# Sheringham Shoal and Dudgeon Offshore Wind Farm Extension Projects

Outline Cromer Shoal Chalk Beds (CSCB) Marine  
Conservation Zone (MCZ) Cable Specification, Installation  
and Monitoring Plan (CSIMP) (Revision B) (Tracked)

## Revision B

Document Reference: 9.7.4

Title:  
Figure 1.1 - Cromer Shoal Chalk Beds MCZ Overview

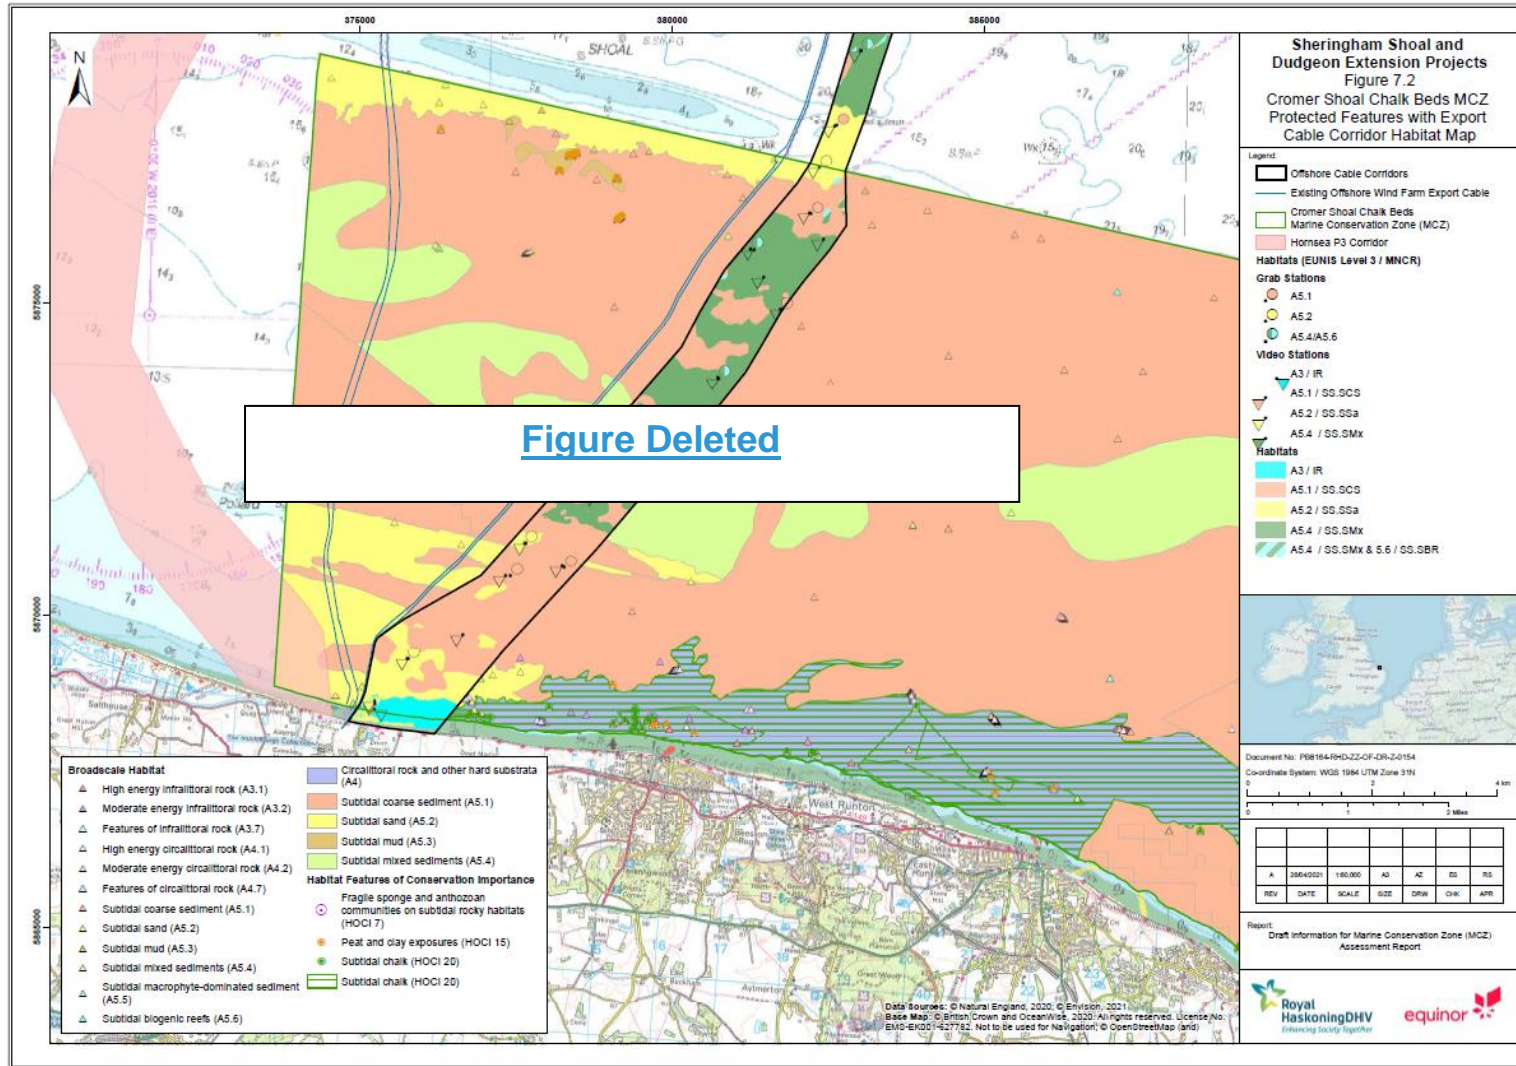
- Secure the Horizontal Directional Drilling (HDD) exit pit location within the Weybourne Channel (Figure 1 and Figure 2 and Section 5.1.5); and
- Include Natural England Relevant Representation [RR-063] comments on this document and the Applicant's response (Table 1).

~~38.~~40. As shown on **Figure 1** and **Figure 2**, the HDD exit pit will be located within the deep infilled channel cut through the chalk to 17m below the seabed, filled with Weybourne Channel deposits (also see **Appendix 6.3 Sedimentary Processes in the Cromer Shoal Chalk Beds MCZ** [APP-182] - visible on **Figure 3.4**), located across the export cable corridor from approximately 750m to 1.5km offshore. Given the depth of overlying sediment deposits there is no potential for exposure of chalk in this area (the depth of the excavation is only up to 1m) and impacts on sub-cropping chalk would be avoided.

Title: Figure 1.2 - Cromer Shoal Chalk Beds MCZ Protected Features

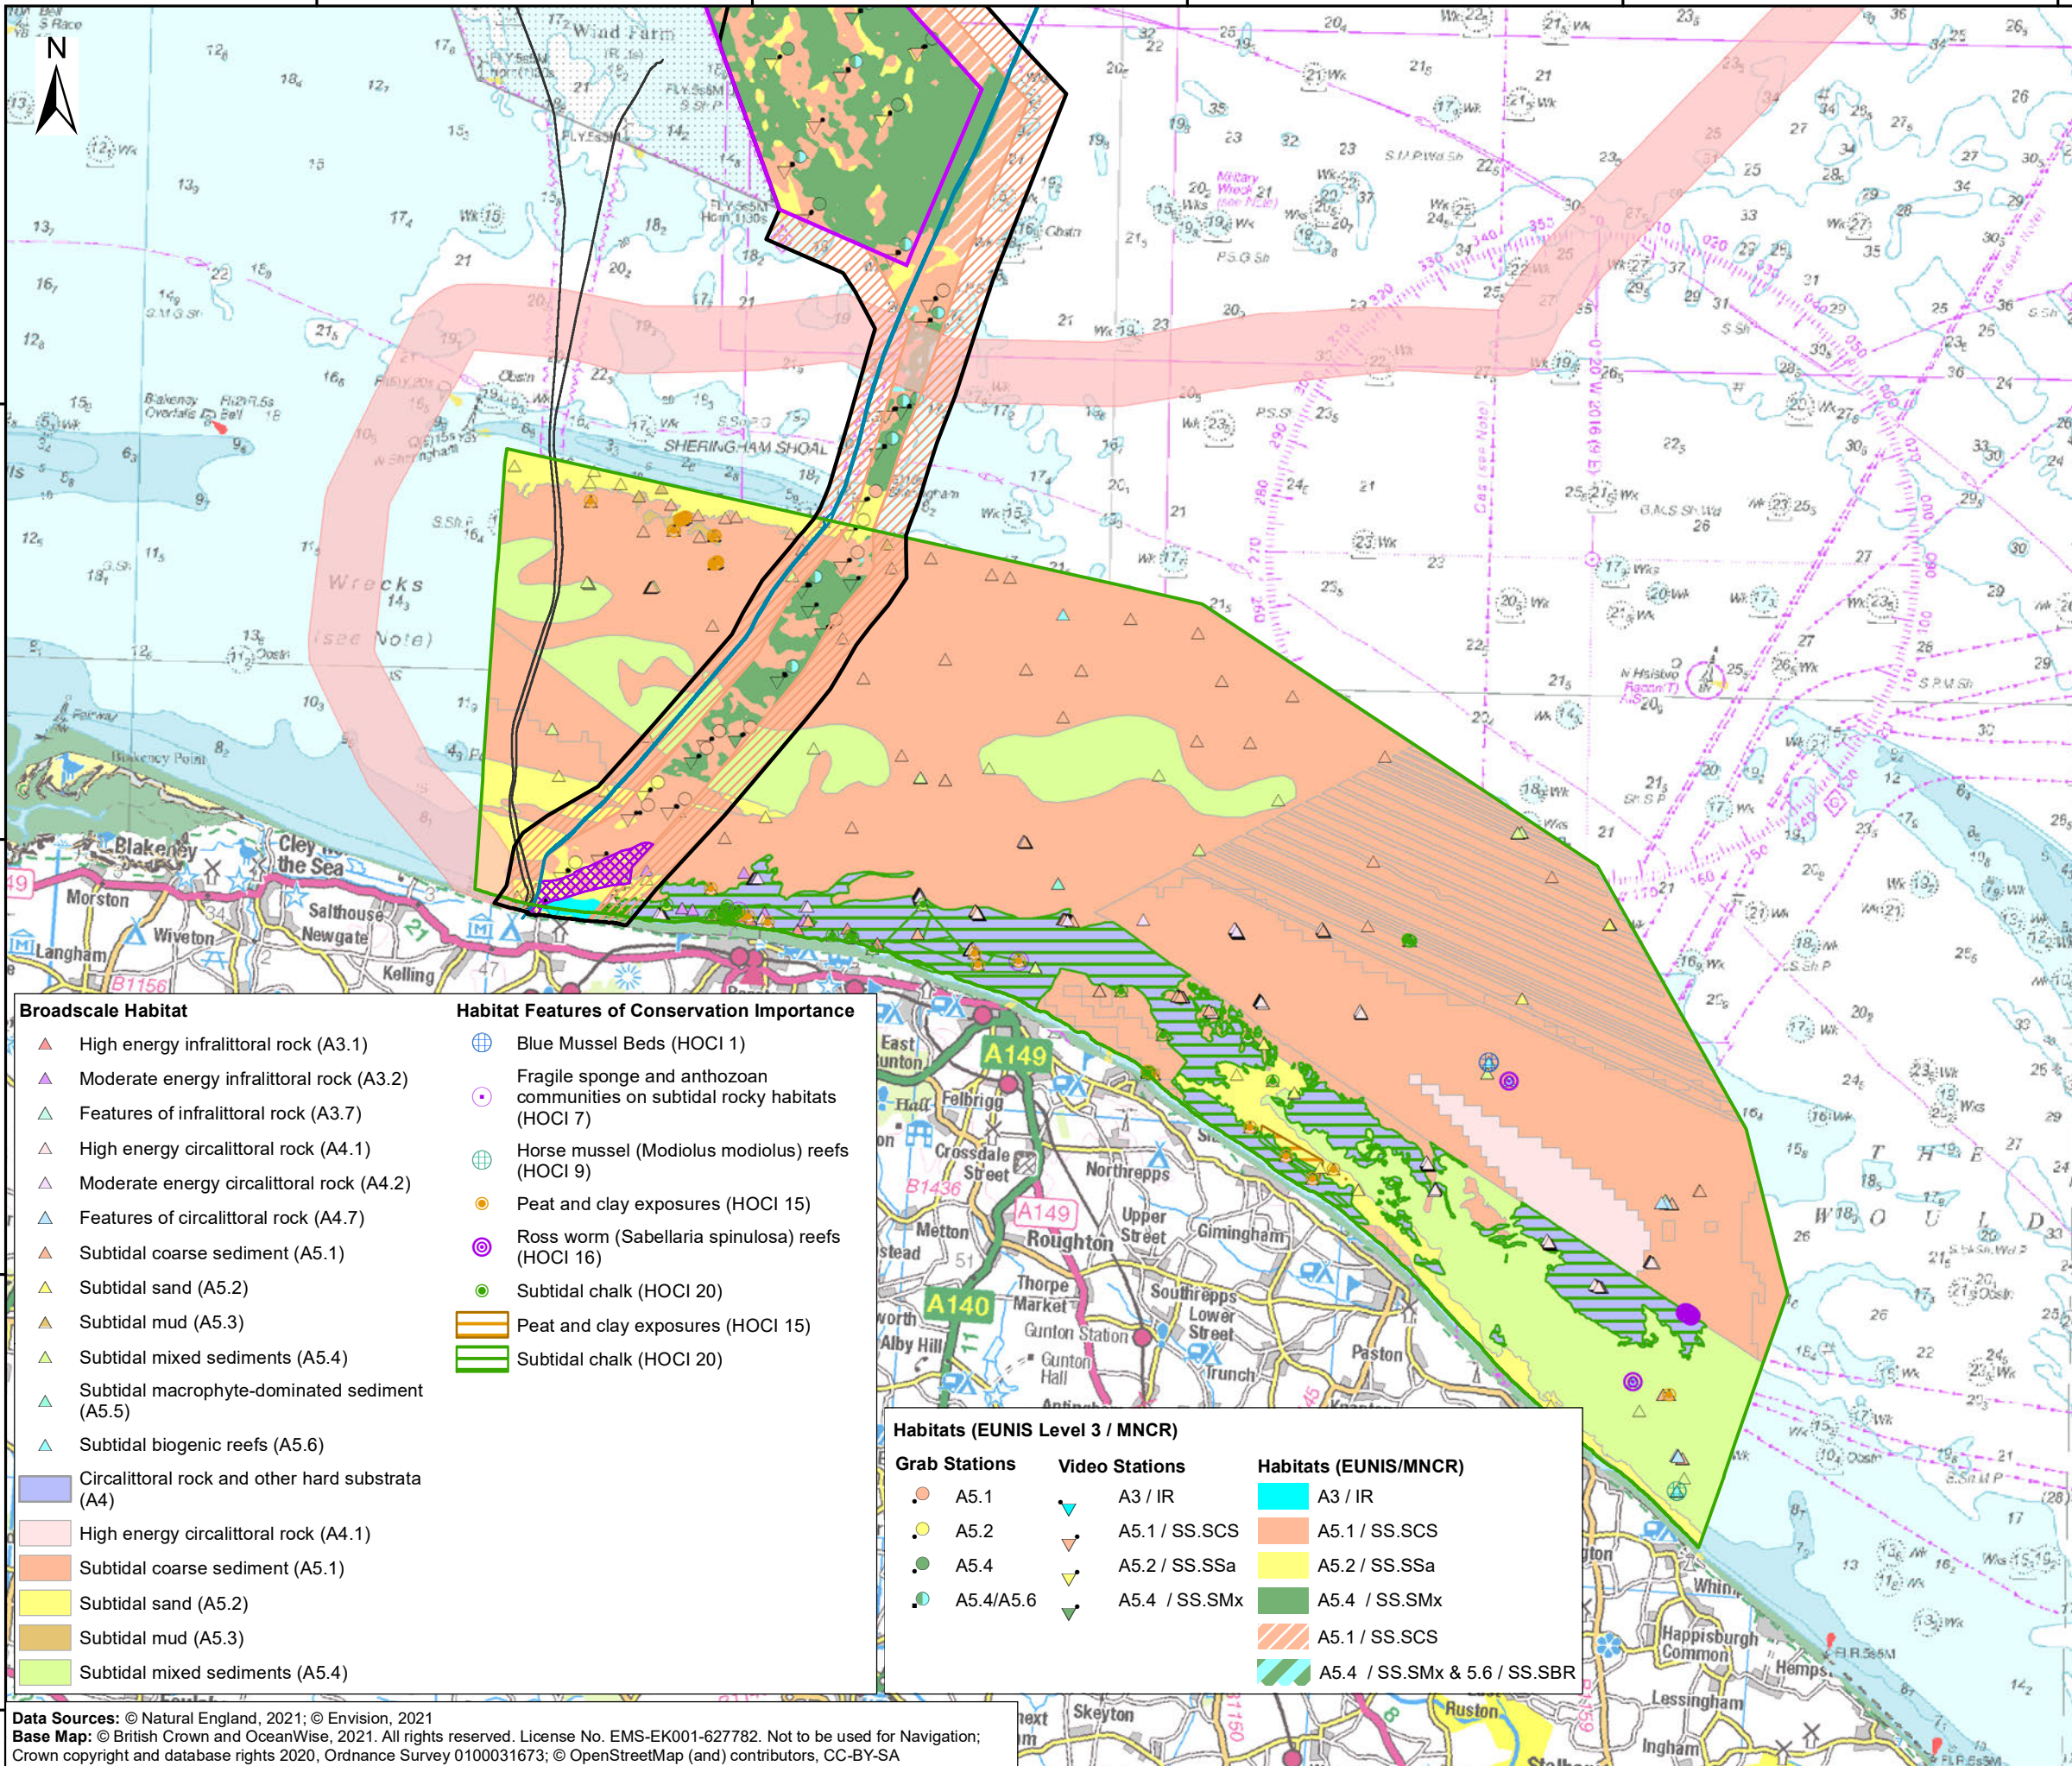
EIFCA	March 2022	Subtidal chalk extent shown in Figure 2 and 1-1 is limited to the A4 circalittoral rock feature, this is not consistent with NE's latest feature advice which shows subtidal chalk (HOCl 20) to be much more extensive. <sup>1</sup>	It was agreed at Sea bed ETG 2 following presentation of evidence contained in <b>Appendix 6.2 Sedimentary Processes in the Cromer Shoal Chalk Beds MCZ</b> (document reference 6.32.6.2) that sea bed sediments in the offshore export cable corridor within the CSCB MCZ are static, with the exception of Holocene sand / subtidal sand, which is mobile under some conditions. Therefore, the potential for subtidal chalk to be exposed in the future is restricted to the subtidal sand areas identified by the geophysical survey.  Further information on the extent of the subtidal chalk FOCl is available in <b>Section 7</b> of the <b>Stage 1 CSCB MCZ Assessment (Revision B)</b> (document reference 5.6).

<p><a href="#">Natural England</a></p>	<p><a href="#">November 2022</a></p>	<p><a href="#">Natural England notes that the information included in Figure 2 and supporting text (1.3.1 para.12) doesn't reflect the more detailed information in 6.3.8.5 Figure 14 which we advise is amended given the purpose of this document.</a></p>	<p><a href="#">The Applicant agrees and has updated Figure 2 to show the more detailed benthic characterisation based on project-specific data.</a></p>

Consultee	Date	Comment Received	Project Response
			In summary, survey data indicates that areas where there is potential for subtidal chalk to be exposed are of very limited extent within the offshore export cable corridor, and it is unknown if any such exposures would meet the criteria to be classified as the subtidal chalk habitat FOCI (e.g. criteria provided by Natural England for Hornsea Project Three (RPS, 2020), or how persistent they would be. Therefore the MCZA is based on the known locations of subtidal chalk restricted to the outcropping subtidal rock feature in the inshore area of the CSCB MCZ only.
EIFCA	March 2022	Will there be further consultation of the final CSIMP with engaged stakeholders in addition to the MMO and NE? This draft CSIMP includes several references to the ES which is not publicly available. Will there be further opportunity to comment when the ES is publicly available?	Following submission of the DCO application, EIFCA will have the opportunity to comment on any of the DCO application submission documents they so wish to respond to. In addition, this Outline CSCB MCZ CSIMP will be updated at the post consent stage in consultation with the MMO and other relevant consultees such as EIFCA.
